**New Hanover County
Environmental Management Department
RFB# 17-0382
REPLACEMENT OF PUMP CONTROL PANELS
Addendum #1**

RESPONSES TO BIDDER QUESTIONS

BOLLARD ETA
NOT TO SCALE

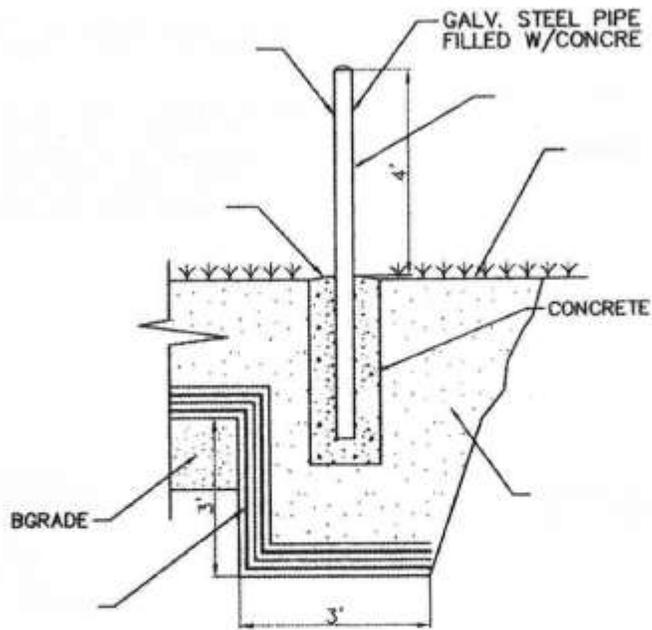
3. Plansheet E-101 references bollards, directing the bidders attention to civil drawing for bollard specifications. Since there are no civil drawings what and where may the bollard specifications be located?

7. The prints E-101 show bollards in front of the panels, where is the spec for the bollards?

Answer: Standard Detail shown on next page. No blocking of access to the panels from the road side should be allowed. The bollards should be located 3 feet from each end of the rack on which the panels are attached and in alignment with the front of the panels. The intent is to protect the panels from traffic on the perimeter road. Coordinate with County staff in finalizing the location in the field.
